New Albany Architectural Review Board
Monday, January 12, 2026, Meeting Minutes - Approved

FDP-88-2025 Healthy New Albany Food Pantry FDP

**HEALTHY NEW ALBANY FOOD PANTRY
FINAL DEVELOPMENT PLAN
CERTIFICATE OF APPROPRIATENESS**

**THIRD STREET MIXED-USE DEVELOPMENT
CERTIFICATE OF APPROPRIATENESS MODIFICATIONS**

2011 Approved Landscape Plan

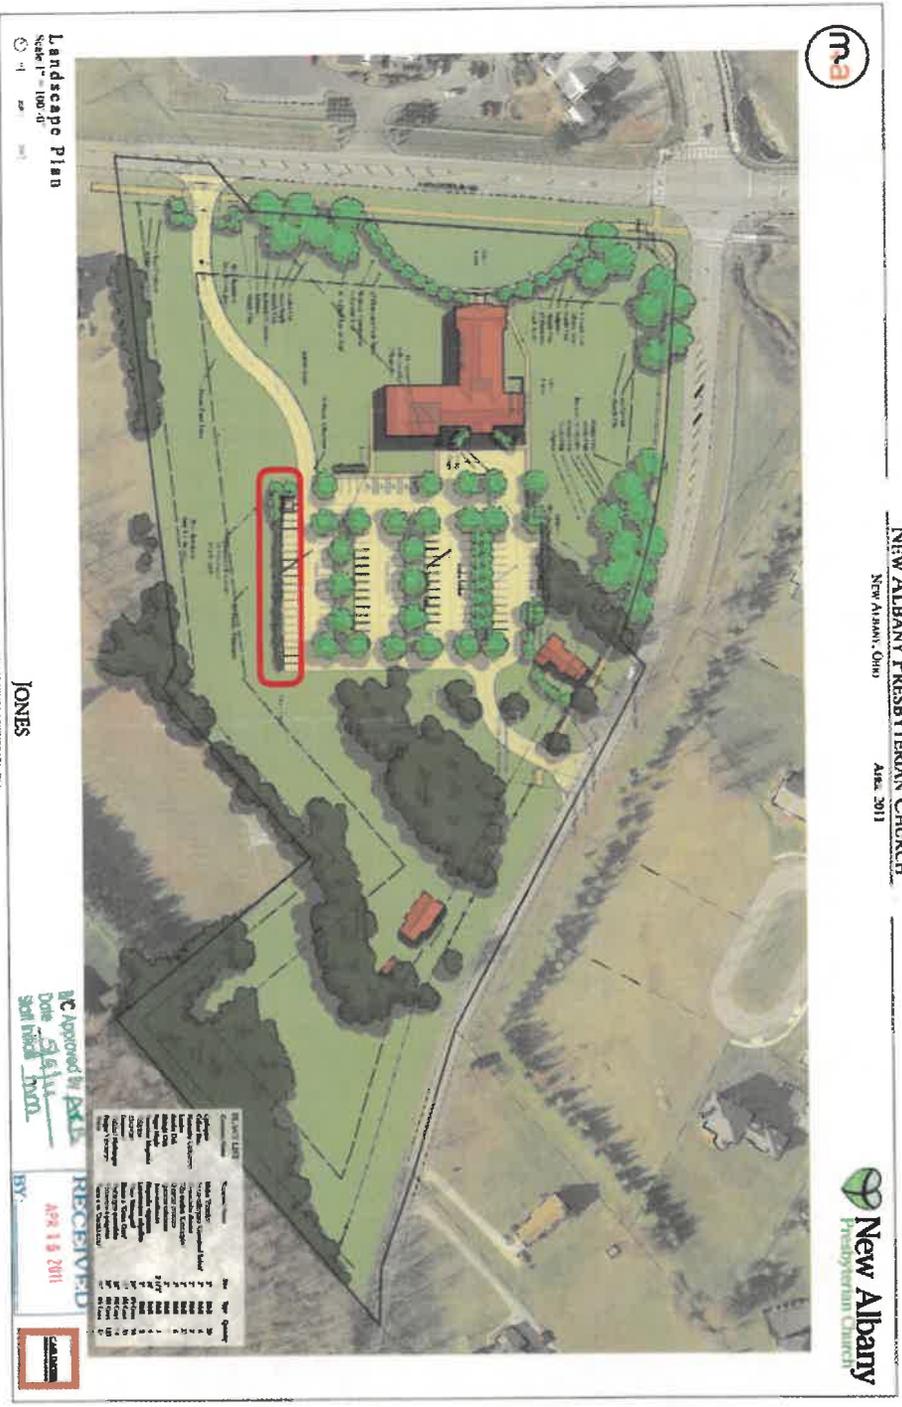
Landscape plan was modified after March 2011 Mtg. to add required parking lot screening
 (Circled in Red below)
